PACT CHARTER SCHOOL  
E.1 SITE PHOTOMETRICS  
04-28-2022

E1.1 - SITE PHOTOMETRICS.pdf V1 - Changemark Notes ( 5 Notes )

**PACT CHARTER SCHOOL  
E1.2 PLAYING FIELD PHOTOMETRICS  
04-28-2022**

E1.2 - PLAYING FIELD PHOTOMETRICS.pdf V1 - Changemark Notes ( 3 Notes )

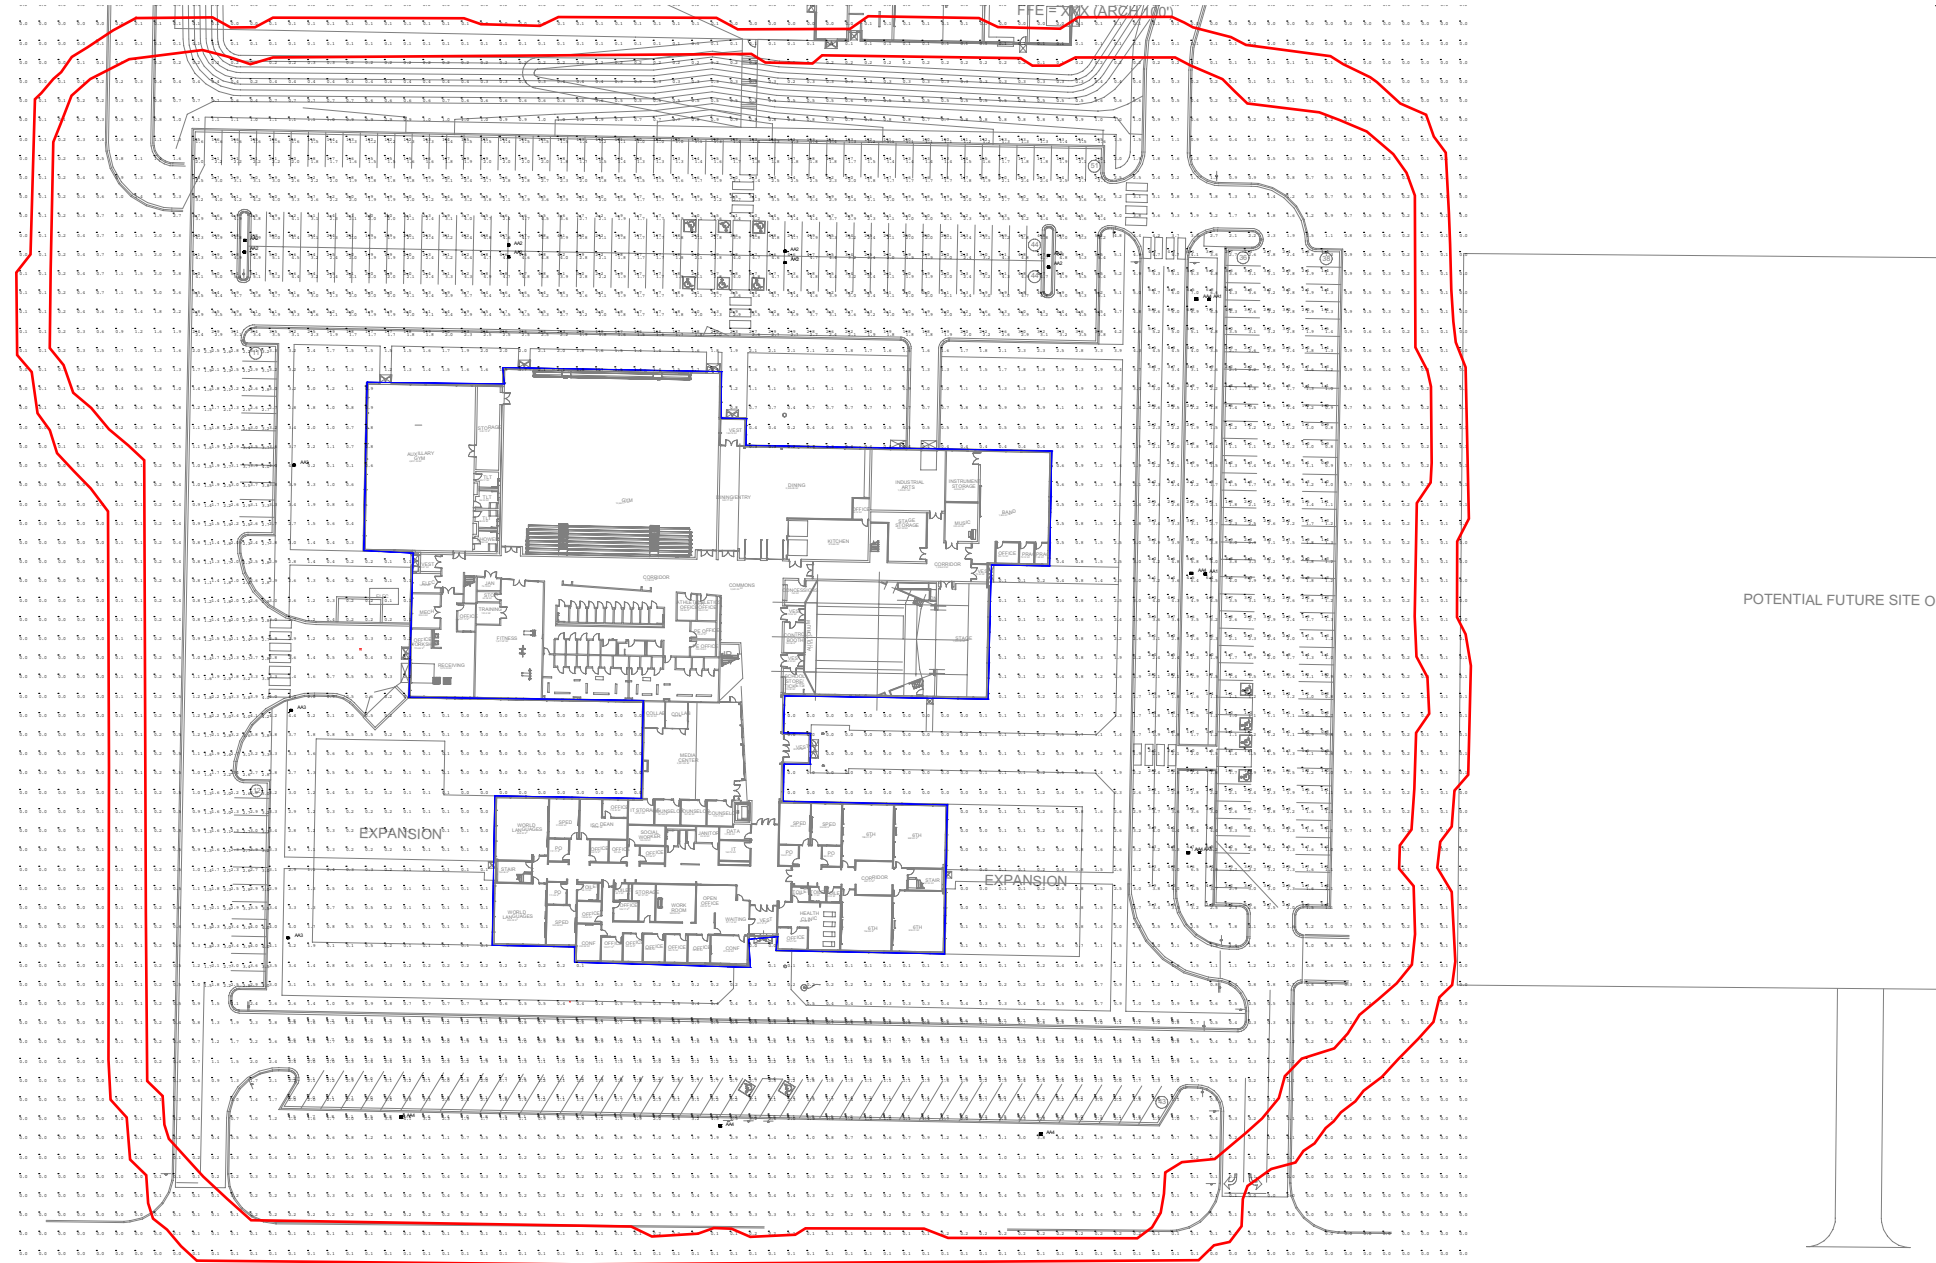
What are the mounting heights? Being this close to residential, max height should be 20 feet.

What is the manufacturer for this fixture? Please provide a cut sheet.

Please show any wall-mounted lights in the calculations.

This area should have at least 1.0 fc, especially if workers will be using it during dark hours.

The front walkway should have at least 1.0 fc

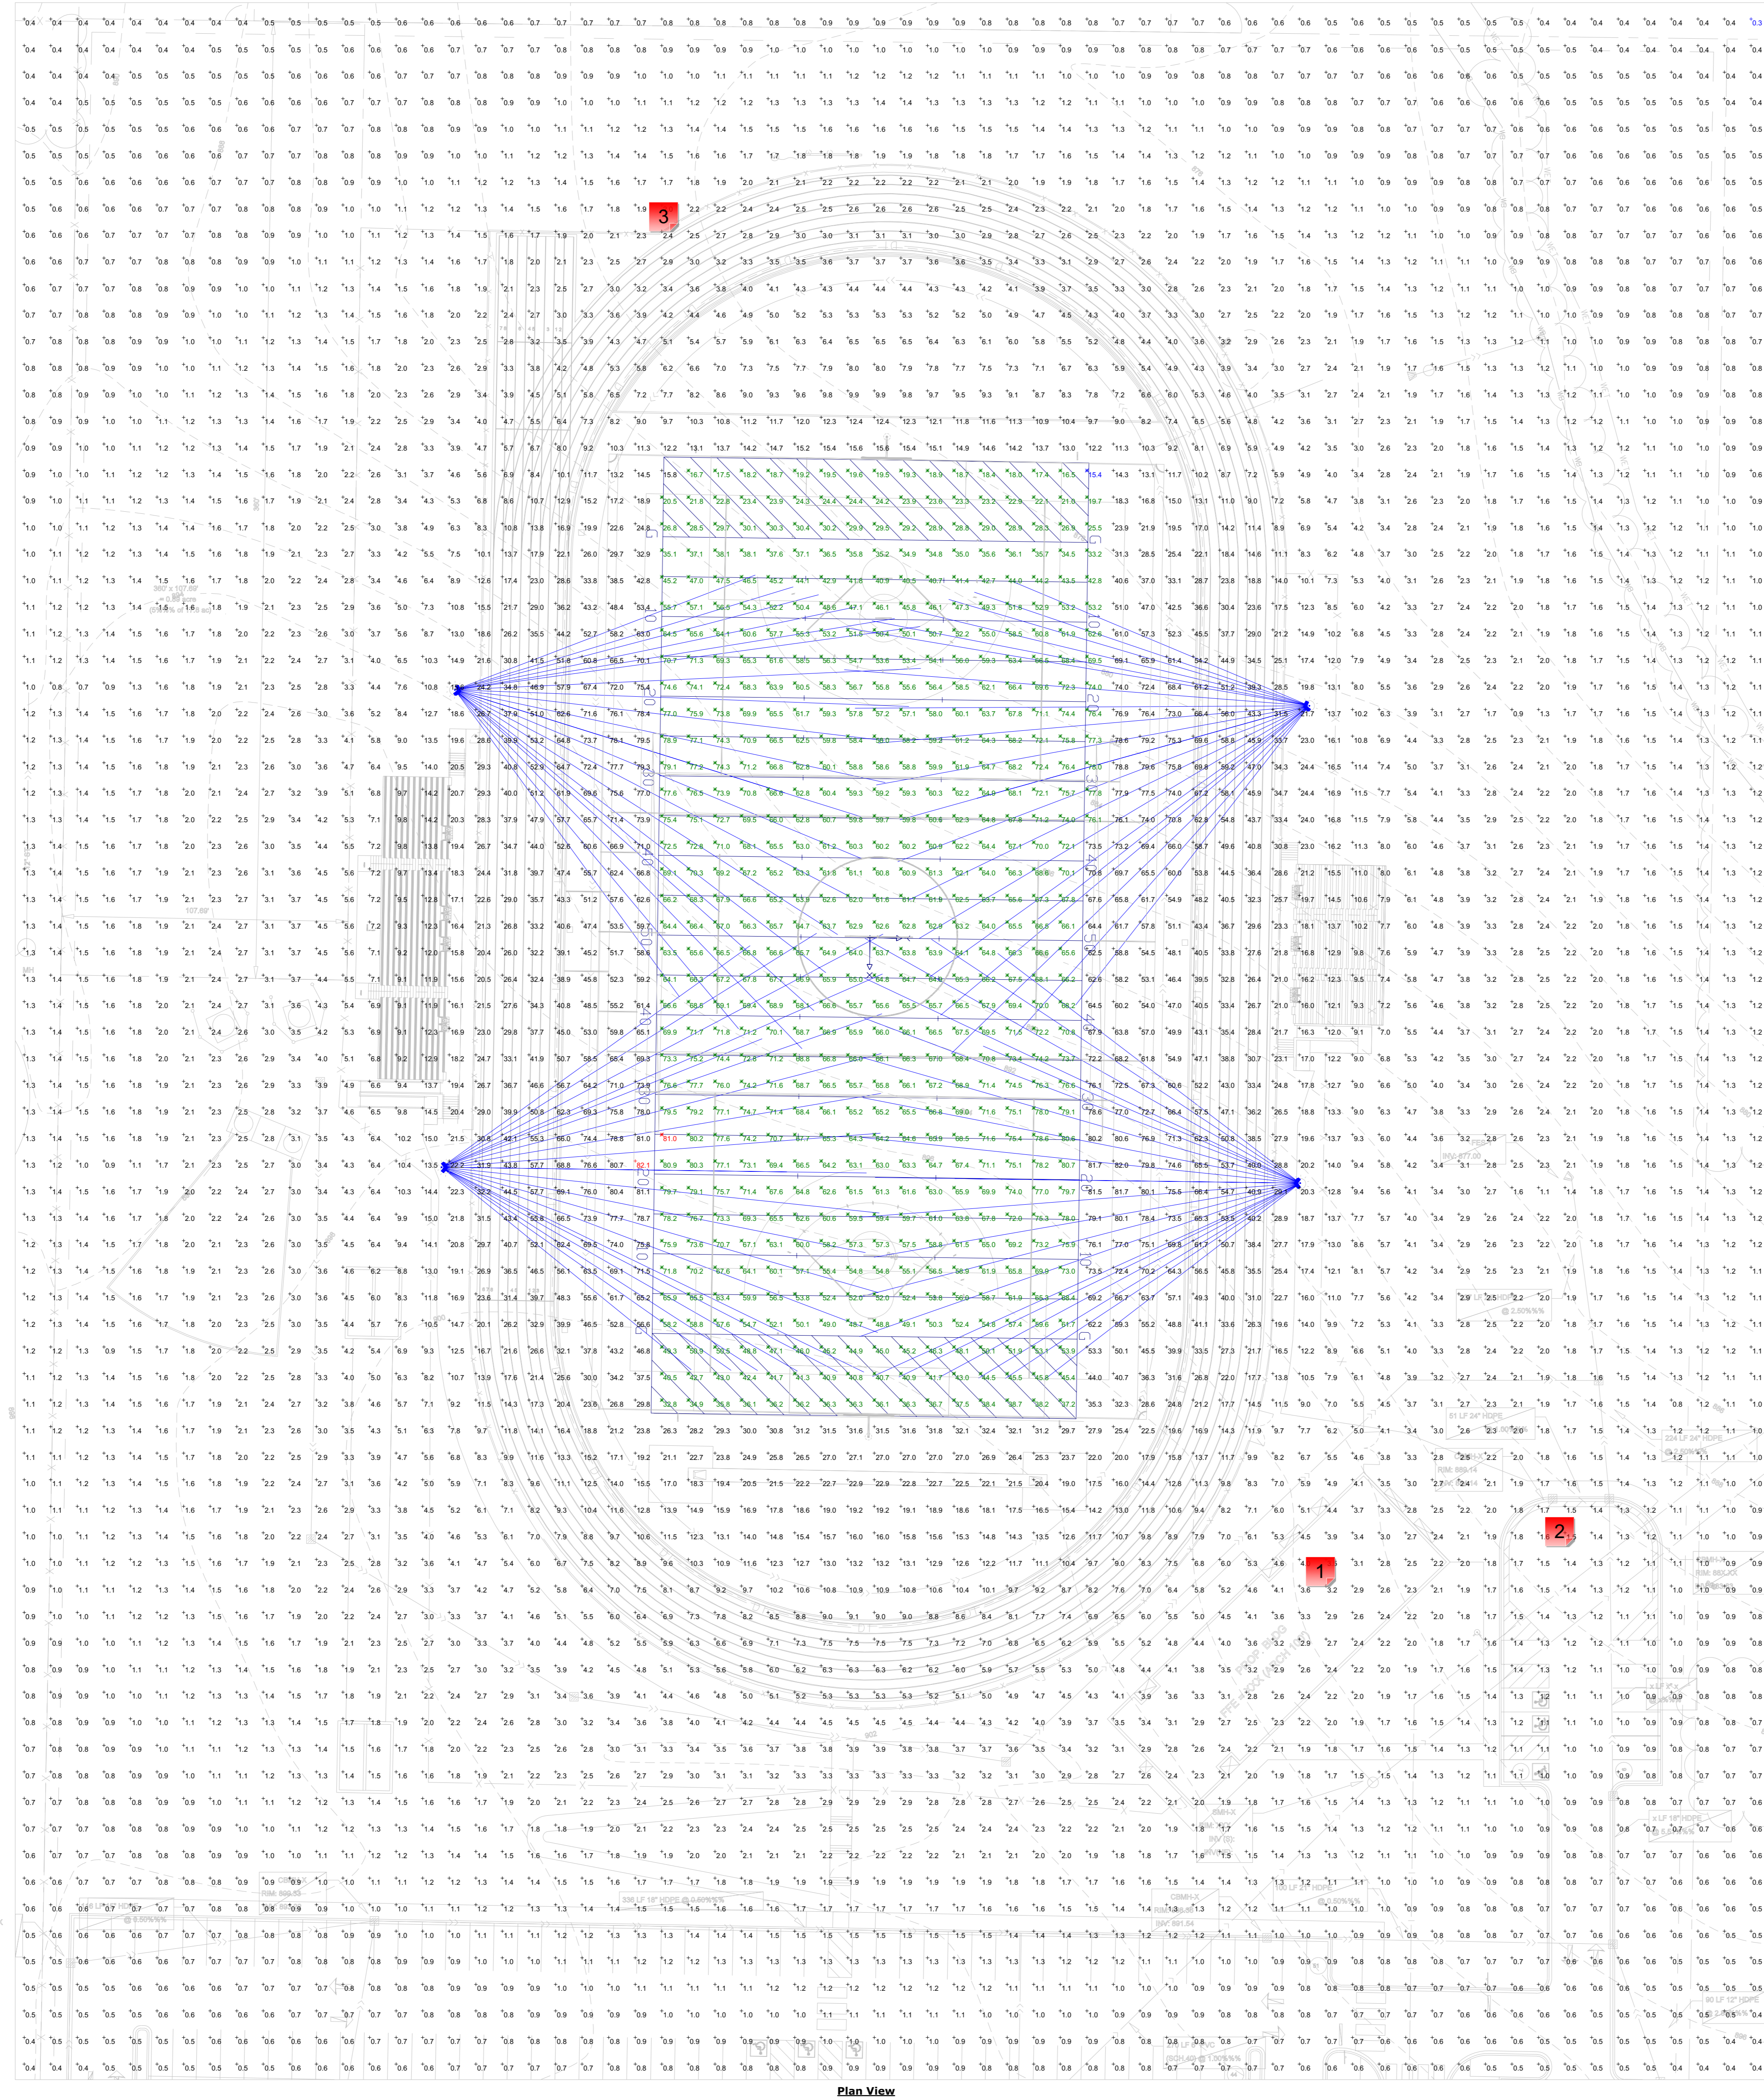
Any building mounted light?

There should be some parking lot lighting here. The stadium lights won't always be on.

Consider a track perimeter of parking lot style lighting in the event the track is used for walking or for maintenance work where use of the stadium-style lighting can be overboard.
